**OFFICIAL COORDINATION REQUEST FOR
NON-ROUTINE OPERATIONS AND MAINTENANCE**

COORDINATION TITLE- *14TDA01 Navlock shoal removal*

PROJECT- The Dalles Dam Downstream Lock Shoal Removal

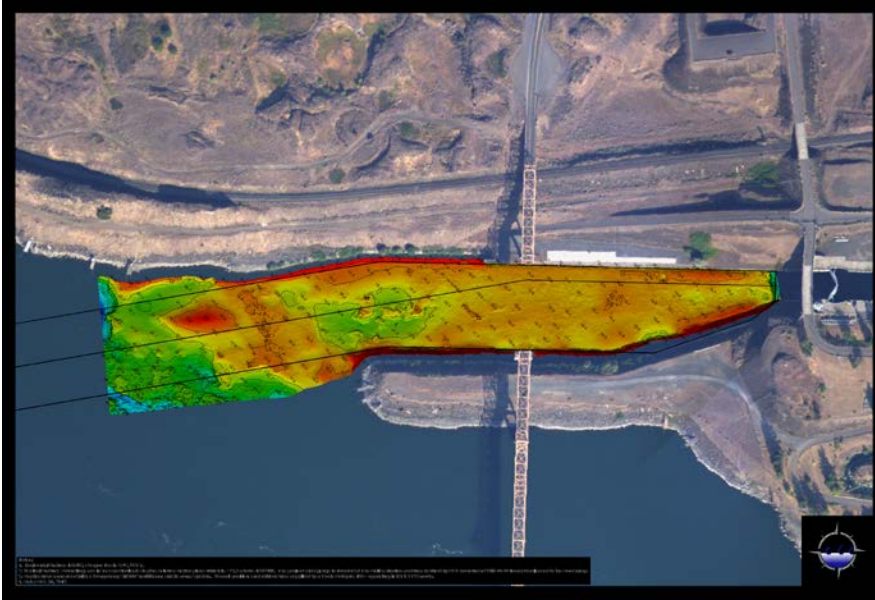
Description of the problem: A shoal has been identified downstream of the lower lock at The Dalles Dam. A contract survey identified an area of concern, showing shoaling above the 14' project. A government survey conducted on 14 November confirmed a small shoal at -10' in the channel (see attached drawing). Grab samples were taken of the material and showed it to be sand. We estimate the quantity at around 1,200 CY. It is our intention to move forward with dredging by contract to remove this shoal. A contract clamshell dredge will be used to remove the shoal.

09 January 2014 FPOM meeting. 14TDA01 Navlock shoal removal. *Tentatively approved.* FPOM (Lorz will confirm no lamprey issues by COB 9 January 2014) didn't have issues with dragging the pile downstream for disposal. They are also ok with the work extending into March.

CRITFC- (via phone call on 10 January 2014)- We are unfamiliar with the drag method and have concerns about impacts to lamprey. We prefer a clamshell, mainly because we are more familiar with the impacts a clam shell may have.

Final results- The PDT decided on a clam shell rather than a drag beam. This work will continue to go forward with the PDT attempting to keep the work within the in-water work window.
